ENGINEERING CHANGE NOTICE

Originator: Phone No. Email Address: Department	Harsh Patel	Date:	Document Number
	(416) 754-3322	July 22, 2021	ECN20210722-00
	hpatel@edac.net	Revision Number	SHEET
	ENGINEERING	1	1 of 2

POLARIZING KEY

DRAWING NUMBER 341-240-001	ISSUE 11
--------------------------------------	-------------

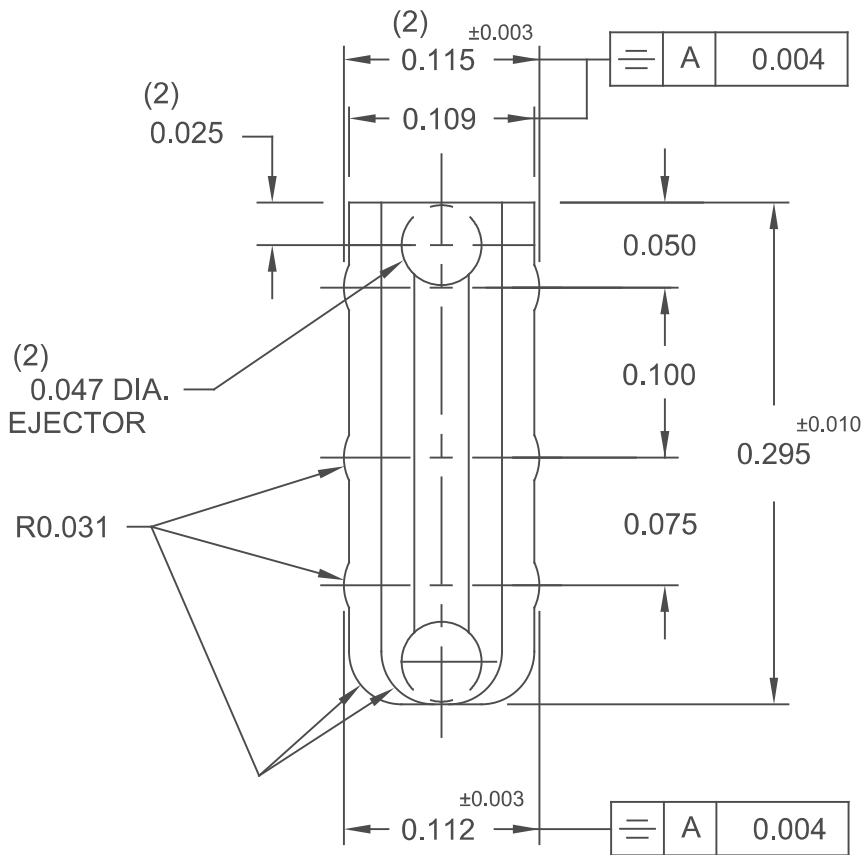
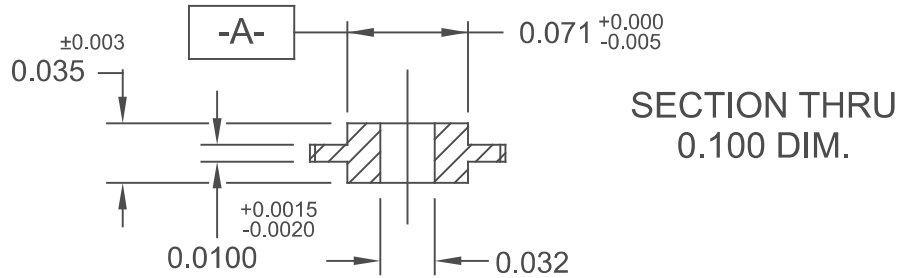
- 1) Discontinuance / End of Life of part number- 341-240-317.
- 2) Colour changed for part number- 341-240-318 from red colour to natural colour.

1. Part number- 341-240-317 is obsolete. part number- 341-240-317 is replaced by part number- 341-240-318. They are both identical.
 2. Colour changed for part number- 341-240-318 from red colour to natural colour as a part of an internal improvement.
- Note:- There is no change in Form, Fit and Function.
3. Effective implementation to distribution is on July 22, 2021.

RE-DRAWN F.BRIONES DEC.8/97	⑨
341-240-318 DELETED F.BRIONES NOV.16/12	⑩
341-240-317 DELETED RESTORE 341-240-318 RED TO NATURAL COLOR N.B. JUL.21/21	⑪

~~PART NUMBER: 341-240-317 (AS MOULDED NOT DYED)~~
PART NUMBER: 341-240-318 (NATURAL COLOR)

- 1- MATERIAL: NYLON 6/6 COLOR NATURAL 30% GLASS FILLED.
- 2- MOLDED PART CONFORM TO EDAC SPEC. 110-0211.
